**PLANNING APPROVAL,
PLANNED UNIT DEVELOPMENT &
SUBDIVISION STAFF REPORT**

Date: November 5, 2015

<u>NAME</u>	CSpire/Claxton Commercial Facility Subdivision
<u>SUBDIVISION NAME</u>	CSpire/Claxton Commercial Facility Subdivision
<u>LOCATION</u>	3208 & 3210 Dauphin Island Parkway (West side of Dauphin Island Parkway, 165'± North of Tallahassee Drive
<u>CITY COUNCIL DISTRICT</u>	District 3
<u>PRESENT ZONING</u>	B-3, Community Business District.
<u>AREA OF PROPERTY</u>	2 Lots / 1.3± Acres
<u>CONTEMPLATED USE</u>	Planning Approval to allow a 148' high cell tower in a B-3, Community Business District; Planned Unit Development approval to allow shared access between two building sites; and Subdivision approval to create two legal lots of record from two existing metes-and-bounds parcels.
<u>TIME SCHEDULE FOR DEVELOPMENT</u>	None given.
<u>ENGINEERING COMMENTS</u>

SITE PLAN

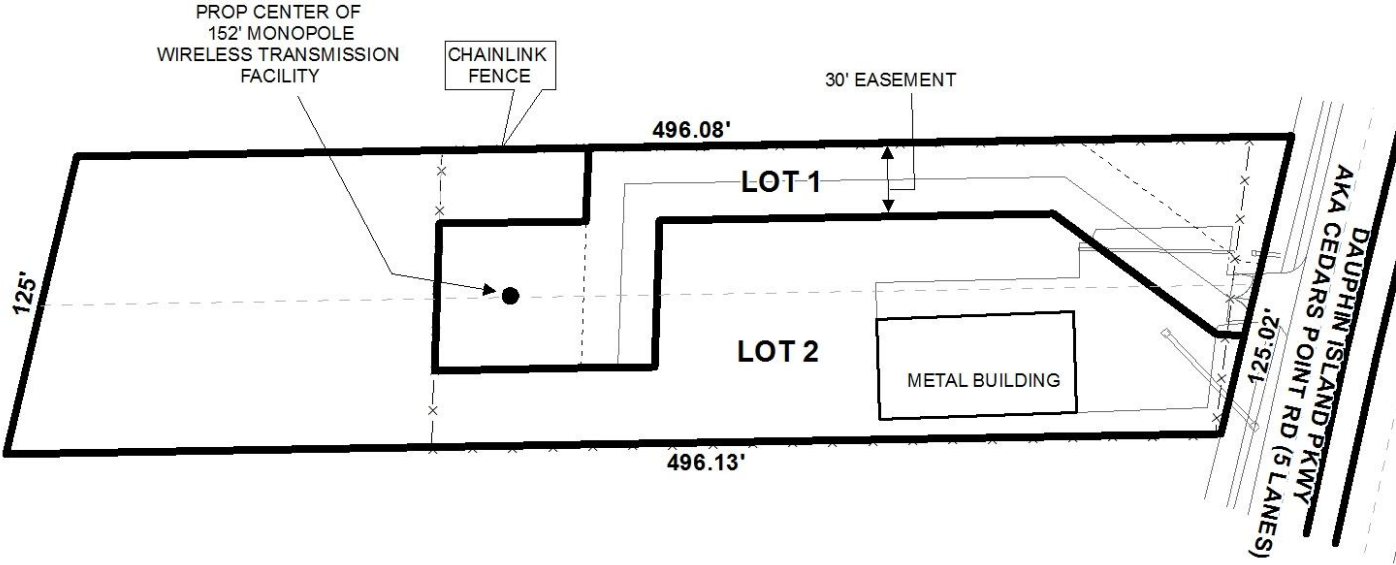
The site plan indicates the tower compound to be approximately 300' into the site from Dauphin Island Parkway and approximately 190' from the adjacent residential property to the West, or rear. It would be in the North-South center of the property. From the compound, an access drive and "finger" of the lease parcel would extend to Dauphin Island Parkway along approximately the Northern quarter of the site and share the existing curb cut used by the machine shop. The entire area consisting of the tower compound and lease parcel is proposed as one of the two lots of the Subdivision. The access drive through the lease parcel to the compound is indicated as being gravel on the site plan and no Paving Surface Variance was requested by the applicant. Therefore, if approved, the site plan should be revised to indicate the access drive to be paved in asphalt, concrete, or an approved alternative paving surface.

The site plan indicates chain link fencing and gates around the tower compound. As the Zoning Ordinance requires an 8' high wooden privacy fence, the site plan should be revised to indicate wooden privacy fencing and gates 8' high around the tower compound.

The site fronts Dauphin Island Parkway, a component of the Major Street Plan, with a planned 100' right-of-way. As the plat did not indicate a current right-of-way width along Dauphin Island Parkway, the plat should be revised to indicate the current right-of-way width, and if less than 50' from the centerline to the front property line of the subject site, dedication to provide 50' from the centerline of Dauphin Island Parkway would be required.

As a means of access management, a note should be added to the Final Plat stating that both lots are limited to one shared curb cut to Dauphin Island Parkway, with the size, location and design to be approved by Traffic Engineering and conform to AASHTO standards. And the plat should be revised to label each lot with its size in both square feet and acres, after any required frontage dedication, or a table should be furnished on the Final Plat providing the same information.

- 1) subject to the approval by the Board of Zoning Adjustment of Height, Setback and Residential Buffer Separation Variance requests;
- 2) revision of the site plan to provide a drive paved with asphalt, concrete or an approved alternative paving surface for the lease parcel area;

- 4) revision of the site plan to provide an 8' high wooden privacy fence and gates around the tower compound;
- 5) revision of the site plan to illustrate the 25' minimum building setback line along Dauphin Island Parkway, as measured from any required frontage dedication;

- 6) revision of the site plan to indicate the current right-of-way width along Dauphin Island Parkway after any required frontage dedication;
- 7) revision of the site plan to label each lot with its size in both square feet and acres, after any required frontage dedication, or the furnishing of a table on the site plan providing the same information;

- 8) placement of a note on the site plan stating that the site is limited to one shared curb cut to Dauphin Island Parkway, with the size, location and design to be approved by Traffic Engineering and conform to AASHTO standards;

DETAIL SITE PLAN

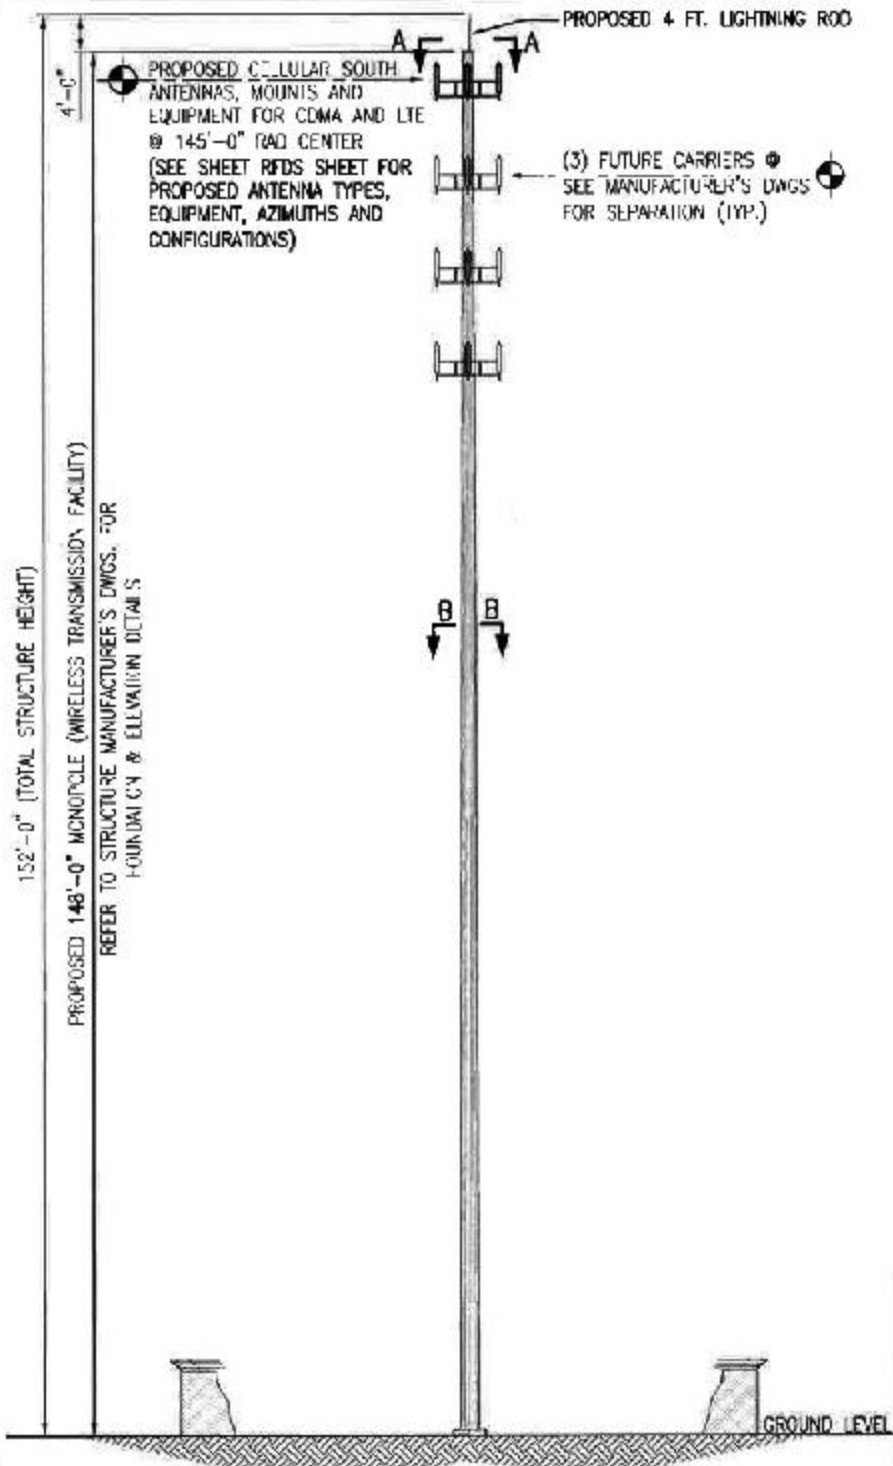
A landscaping plan was submitted by the applicant indicating understory trees around the tower compound. As overstory trees are required, the landscaping plan should be revised to indicate overstory trees, to be coordinated with Urban Forestry, at a ratio of one tree per every 30 linear feet of compound perimeter.

- 3) revision of the site plan to provide overstory trees, to be coordinated with Urban Forestry, at a ratio of one tree per every 30 linear feet of tower compound perimeter;
